Rear Brake Caliper Retaining Bolts –  
Change of Specification

MODEL 1995 MY  
Sedan Range  
VIN  
720001 - ON

ILLUSTRATION 1

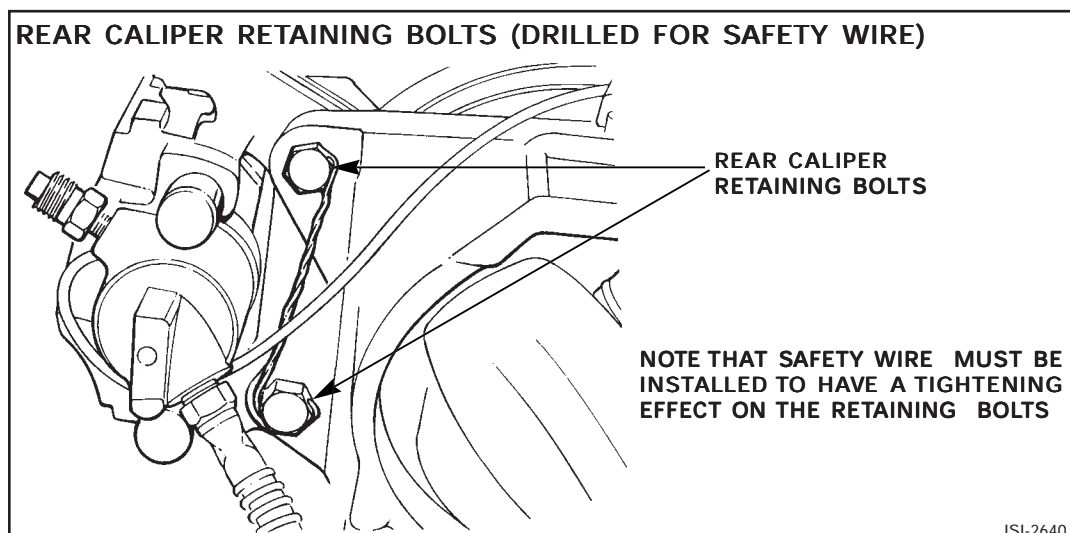
The two bolts that retain each rear brake caliper to the hub carrier have been changed from a cross-drilled design, which must be safety-wired, to a self-locking design beginning with VIN 761784.

*Safety-wired retaining bolts (Illustration 1) can be reinstalled provided they are in good condition and are safety-wired after being tightened to the correct torque. These bolts can be replaced by the new self-locking retaining bolts.*

*Self-locking retaining bolts* must be discarded after one use. Replace with new self-locking retaining bolts, part no. JZB 100060.

*Rear caliper bolt torque:* 40 - 48 lb. ft. (54 - 66 Nm)
